RE: F-98-42, Buckskin Lake Overlook
Lots 5,6,& Preservation Parcel A

RE: Buckskin Lake Overlook (Resub. Lot 4 David Mullinix)

RE: Percolation Certification Plan
Buckskin Lake Overlook
Folly Quarter Road
Tax Map: 22 Parcel #73

A# 42190

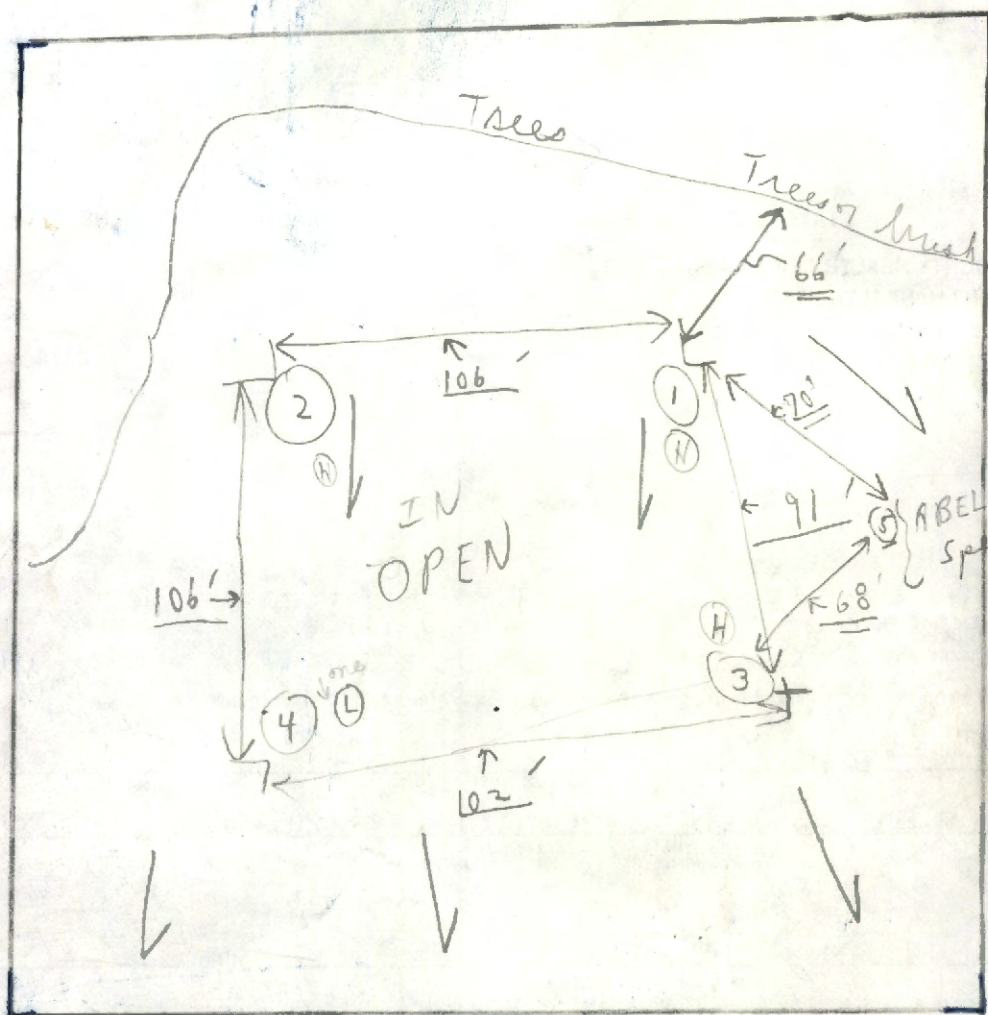
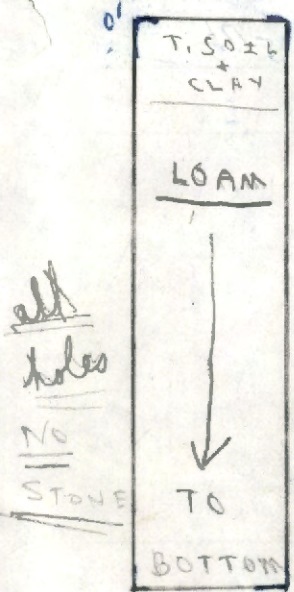
REASONS FOR REJECTION OR HOLDING 9/6/88 Holding for house site,

well site and certified holes for septic

area. C.B.D.

A# 42190

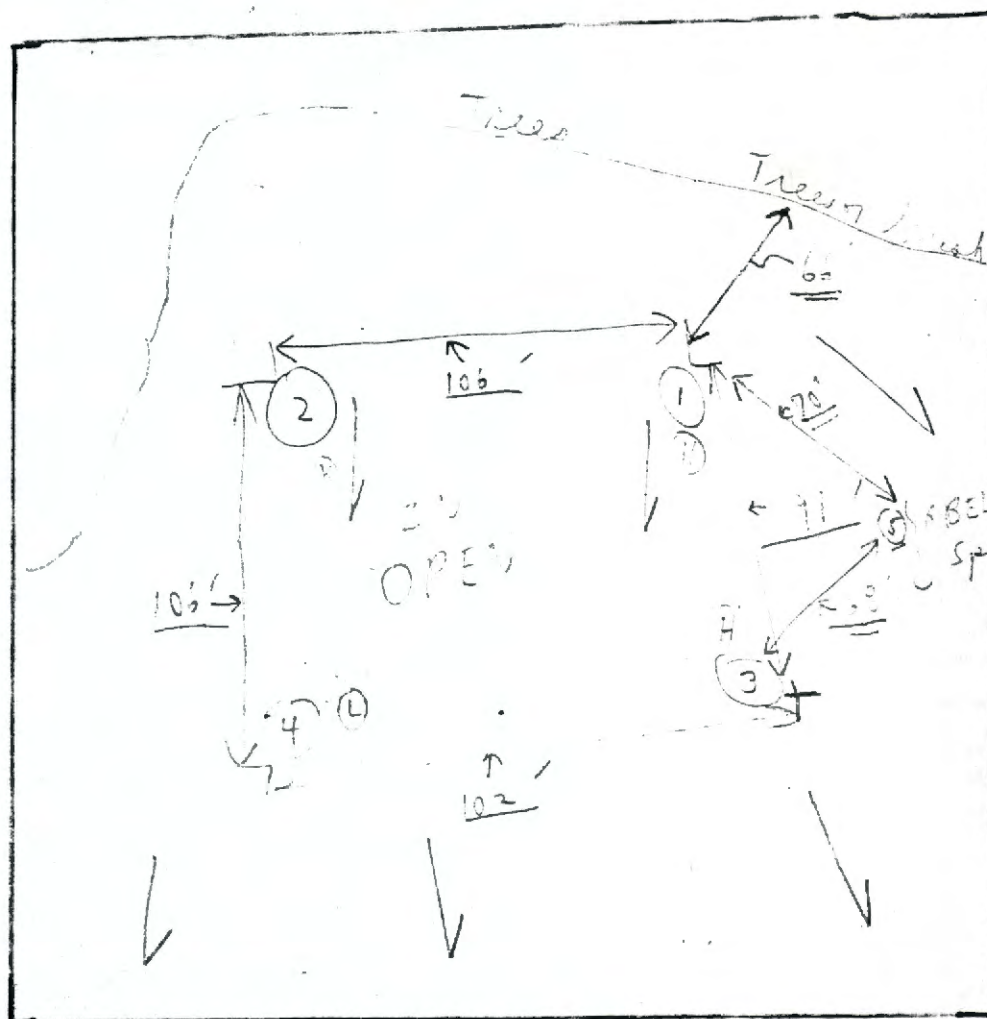
9/6/88 - 7/1/89 for house - site
well site not established - holes for water
area. C.B.D.
